**Louisville - Southern Indiana Ohio River Bridges Project
Indiana and Kentucky Historic Preservation Advisory Team
Meeting – December 13, 2007
TARC Administration Building**

The meeting was turned over to the members of SDC 2 who began the second round of a three workshop session with discussions of architectural design details of the Downtown Bridge.

Option 1 -
Tapered/Angular Towers and Piers

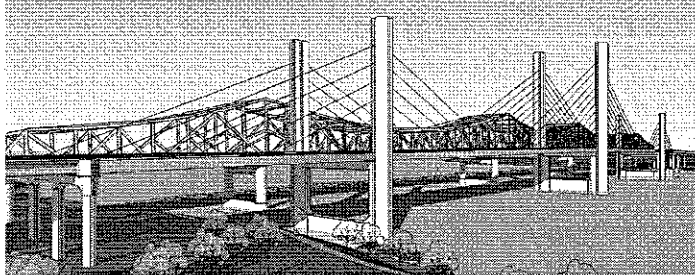
- Prefer angular/tapered towers
- Due to their massing and form, the elliptical towers and piers seem less elegant.
- The tapered towers and piers compliment the architectural features in the surrounding areas, as pointed out in the presentation (church spires, etc.)
- Elliptical towers are too massive/bulky

Option 1 – Tapered/Angular Towers and Piers (all tapered/angular)

Voting Average: **8.43**

- Option 1 presented relatively less bulk and mass than other options and is preferable.
- Regarding the bridge underside: more examples of actual surface treatments are needed. If possible, would like to see photos or depictions of Woodrow Wilson Bridge or new Oakland Bay Bridge.
- Regarding view from Louisville Waterfront Park path: potential future federal security restrictions under the bridge are a possibility. These restrictions could pose additional Section 4(f) and possibly Section 6(f) impacts on both Louisville Waterfront Park and Jeffersonville Greenway that were not analyzed in the Environmental Impact Statement.

Option 2 -
Elliptical Towers and Piers

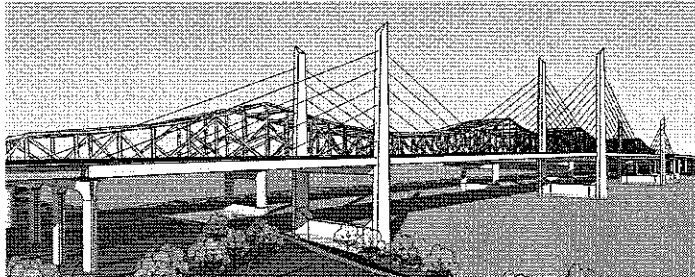
Option 2 – Elliptical Towers and Piers (all elliptical)

Voting Average: **1.71**
